Planning and Land Use Committee Report

For the Meeting on July 3, 2014

Subject: **Development Permit with Variances #000360 for 787 Tyee Road**
Application to construct a 49-unit multi-family residential building (Bonds Landing Phase 3).

1 EAST ELEVATION

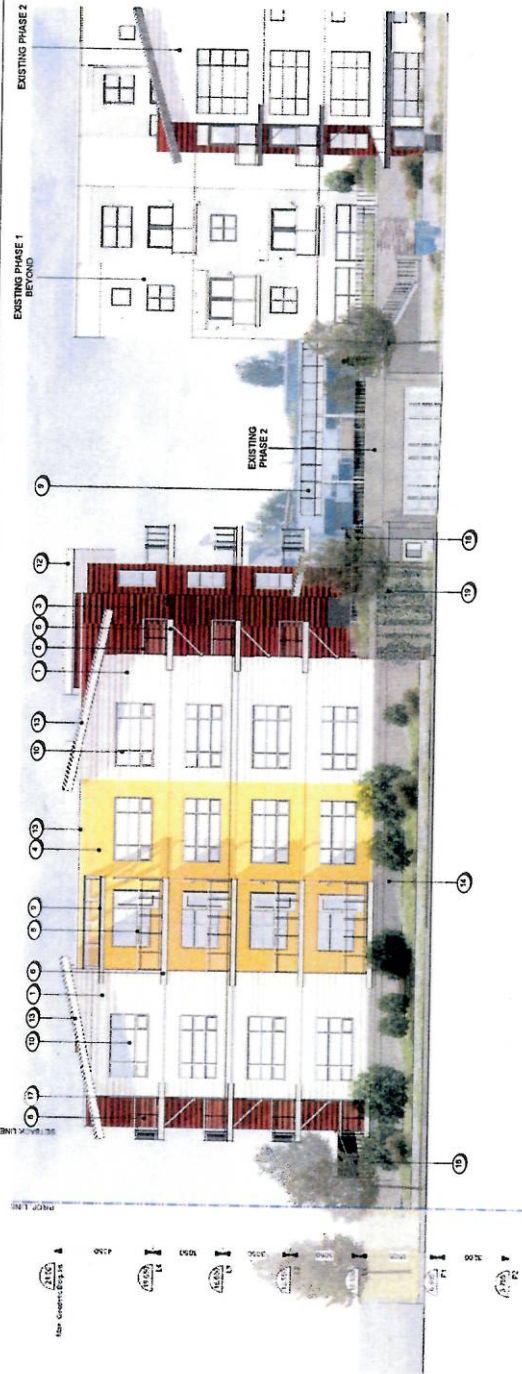
However, staff are concerned with the relationship between the proposed building and Central Spur Road. As a result of site grade and the existing parkade access design and location, the proposed parkade level of the building would be raised above Central Spur Road. The application indicates that this exposed parkade wall will be finished with concrete. Staff recommend that Council require revisions to the satisfaction of the Director of Sustainable Planning and Community Development, refining the exposed parkade wall, to ensure an attractive sidewalk on Central Spur Road, prior to the issuance of the Development Permit.

The proposed development would be served by an underground parkade utilizing an existing access from Central Spur Road. The parkade design and site grades are such that part of the parkade is protruding above Central Spur Road. This results in a significant area of exposed concrete at street level on the east elevation of the proposed new building. This issue was addressed in an earlier phase of development by providing townhouses adjacent to the street with an underground parkade immediately to the rear of the units, however, replicating this solution in Phase 3 would result in the loss of several parking stalls. While the applicant has indicated that some landscaping would be provided to soften the impact of the exposed concrete elements, staff recommend that Council require design refinements to the east elevation of the building to ensure a positive street relationship with Central Spur Road. These refinements could include the use of alternative finishing materials, colour treatment and additional landscaping. The staff recommendation includes this requirement.

The proposed Development Permit Application is generally consistent with the *Railyards Development Guidelines* and the proposed building design is similar to Phases 1 and 2 of Bonds Landing; however, design refinements to the lower levels of the east elevation would be a positive improvement.

- visitor parking spaces to 6 visitor parking spaces.
2. The submission of revised plans refining the parkade level of the east elevation of the proposed building to ensure a positive street relationship with Central Spur Road.
 3. Final plans to be in accordance with the plans identified above to the satisfaction of the Director of Sustainable Planning and Community Development.
